P.A. Ref: 25/44048
ACP Ref: 324030-26

LRD Meeting held on 11/12/24 under Section 247 of the Planning and Development Act 2000 (as amended)

Cork City Council
 Planning and Integrated Development Directorate
 LRD Opinion Meeting Minutes Ref: LRD25-03

Re. MAGLIN LRD Greenfield LRD – Opinion Report
Planning Ref. LRD25-03
Date: 27 May 2025

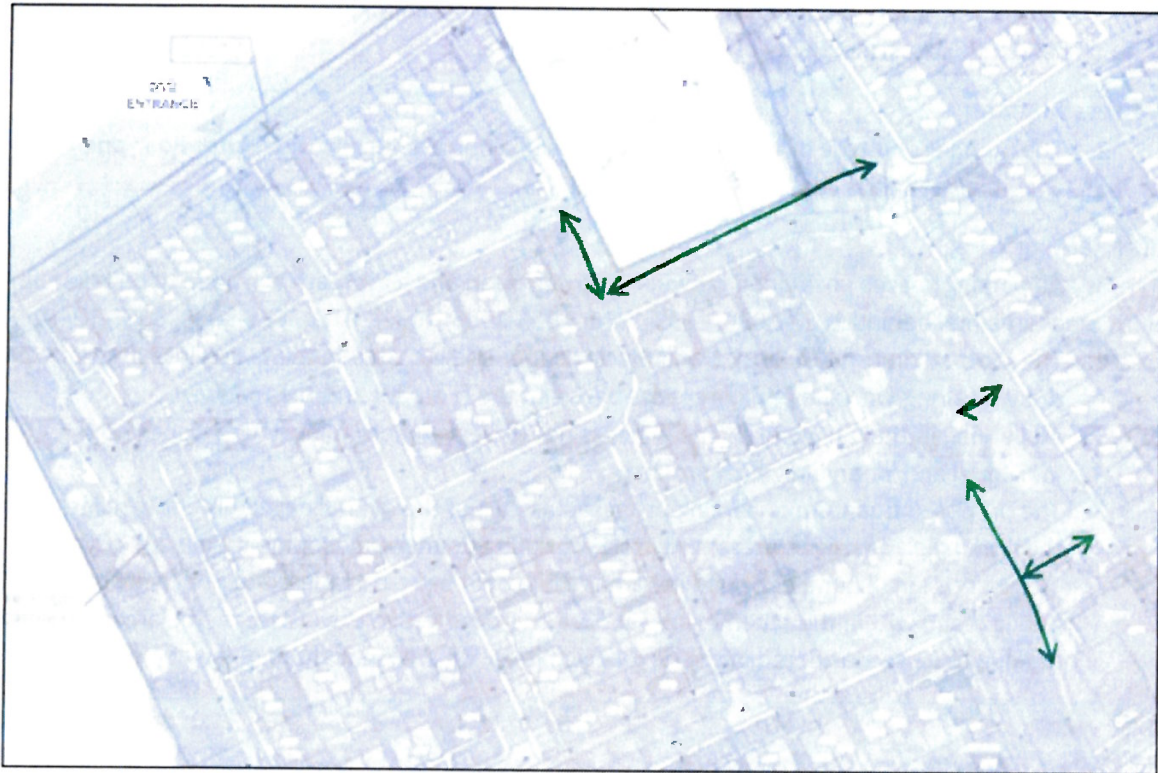
site focusing connectivity both internally and externally within the site. I have the following connectivity issues to be addressed in the next design iteration.

- Short Additional footpath south of 1001
- New Footpath opposite 4015 (on the other side of the road)
- New Footpath opposite 4001-4006 (on the other side of the road)
- Short Additional footpath west of 1090
- Extend Active travel route to the west of the Creche, remove route through the bike store
- Extend Active Travel Route to the north of the bike store (Creche)
- Convert active travel route in front of Block 1 and Block 2 to just a footpath.
- Provide a footpath between the creche and its neighbouring parking
